Economic Commission for Europe**Inland Transport Committee****Working Party on Customs Questions affecting Transport****Group of Experts on Conceptual and
Technical Aspects of Computerization of the TIR Procedure****Second session**

Geneva, 25–28 May 2021

**eTIR conceptual, functional and technical documentation version 4.3:
Amendments****Amendments to the eTIR conceptual, functional and
technical documentation - v.4.2 and draft 4.3****Note by the secretariat****I. Introduction**

Figure I
Proposed new high-level architecture of the eTIR system

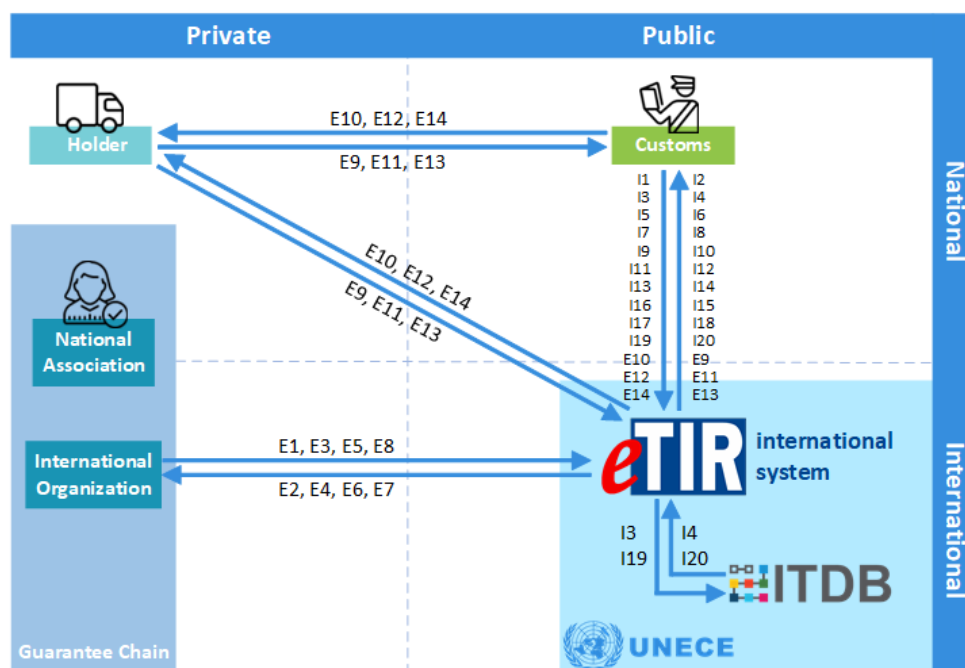
36. Currently in the eTIR specifications, the eTIR international system uses the message pair I3/I4 to get information on the holder and the message pair I19/I20 to get information on customs offices from ITDB. While customs authorities could access this information directly from ITDB (using communication protocols established by TIRExB), they may also wish to be able to get this information by querying the eTIR international system (using the communication protocols established in the eTIR specifications), thus acting as a bridge between them and ITDB. The following figure presents this new architecture in which messages I3/I4 and I19/I20 have been added between customs authorities and the eTIR international system.

37. The Group of Experts may wish to consider this proposal and instruct the secretariat to include in the eTIR specifications, this optional possibility for customs authorities to be able to use messages I3/I4 and I19/I20.

Figure II
Guarantee state diagram

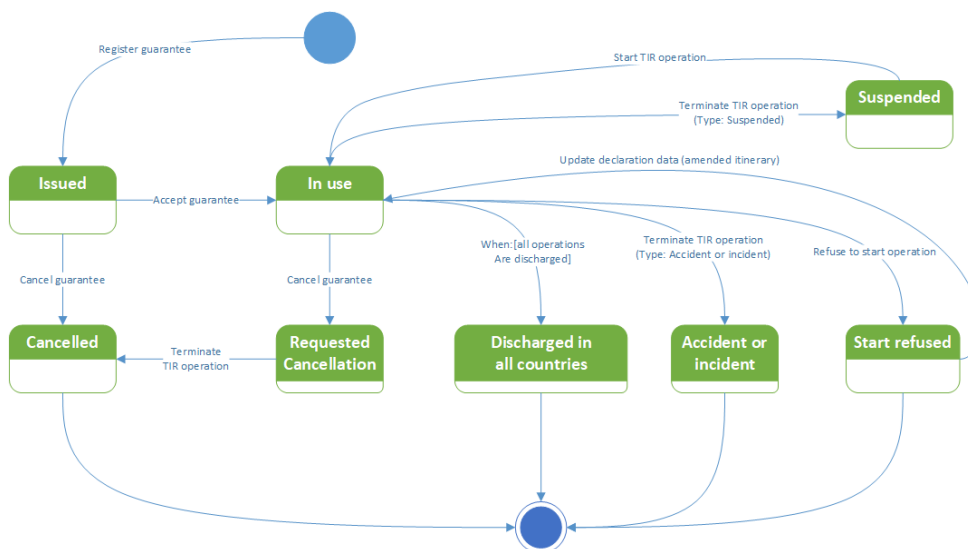
38. At its first session (January 2021), the Group of Experts agreed that the suspension of the eTIR procedure for legs of an intermodal transport would start once a terminate TIR operation message (I11) would be sent with a “suspension” termination code. The eTIR procedure would then be restored at the end of the leg during which the eTIR procedure would have been suspended, when customs would start TIR operation message (I9), and the transport could then continue normally.

39. The secretariat therefore proposes to the Group of Experts to create a new guarantee status called “Suspended” to adequately record this suspension. The following figure shows an updated state diagram of the guarantee including this new state as well as the relevant transitions.

40. The Group of Experts may wish to consider this proposal and instruct the secretariat on whether this new status should be included in the case of suspension of the eTIR procedure.

Figure IV
Processes in an update cycle

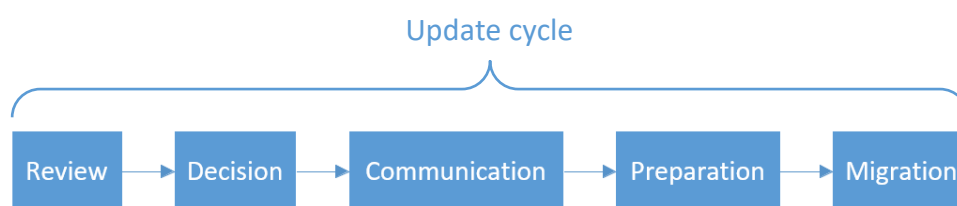
53. The update cycles would consist of a sequence of processes and the length of each of these processes, as well as the overall length of the cycle, would need to be defined by the Technical Implementation Body (TIB). The following figure shows the processes involved in an update cycle.

54. Each process would consist of the following activities:
1. **Review:** the secretariat reviews the latest versions available of the external code lists and prepares a proposal to update one or more of these code lists. The secretariat can also use this opportunity to update one or more of the internal code lists.
 2. **Decision:** the secretariat presents the proposal to TIB which decides on the list of code lists to update and assign a new version of the eTIR specifications to it by incrementing its “update” version.
 3. **Communication:** the secretariat informs all eTIR stakeholders about the new versions of the code lists that will start to be valid at the beginning of the migration time window.
 4. **Preparation:** the secretariat upgrades the eTIR international system to include the new version of the code.

5. **Migration:** At the beginning of this period, eTIR stakeholders can start exchanging messages using the new version of the eTIR specifications. Messages can still be exchanged using the current version of the eTIR specifications until the end of the migration period. This period gives the time needed for the eTIR stakeholders to include the new versions of the code lists in their information systems.

Figure V
Code lists class diagram

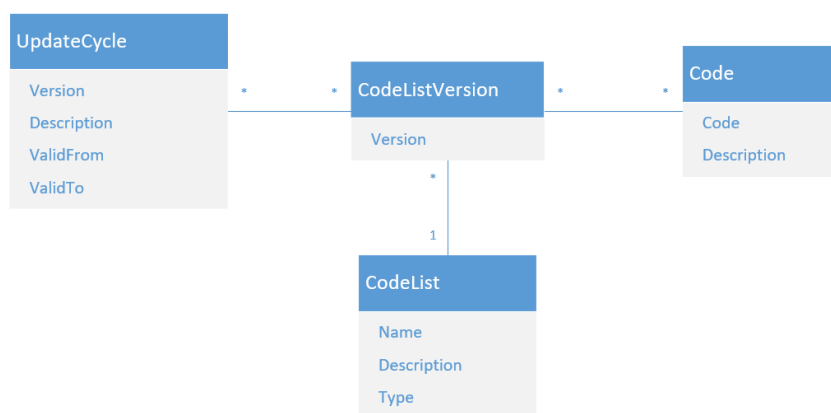
55. The update cycles, code lists and their codes should be managed in the eTIR database. An update cycle is linked to specific versions of all code lists. Code lists can be of two types: internal (managed by the secretariat) or external. Most of the time, only a few codes differ from one version of a code list to another. Therefore, the design of the structure should allow to link one code to several versions of the same code list to prevent unnecessary duplication of codes. In the eTIR technical specifications, the secretariat gives a set of examples to further describe how this is implemented with this approach. The following figure shows the class diagram of the structure.

56. With such an overall approach using update cycles, users of the eTIR system would get an update of the code lists used by the business community on a regularly and predictable basis. In addition, the design proposed allows for proper management of code lists over time, including being able to query information related to TIR transports that happened in the past with previous versions of code lists.

57. The Group of Experts may wish to consider this proposal and guide the secretariat on whether it should be included into the eTIR specifications.
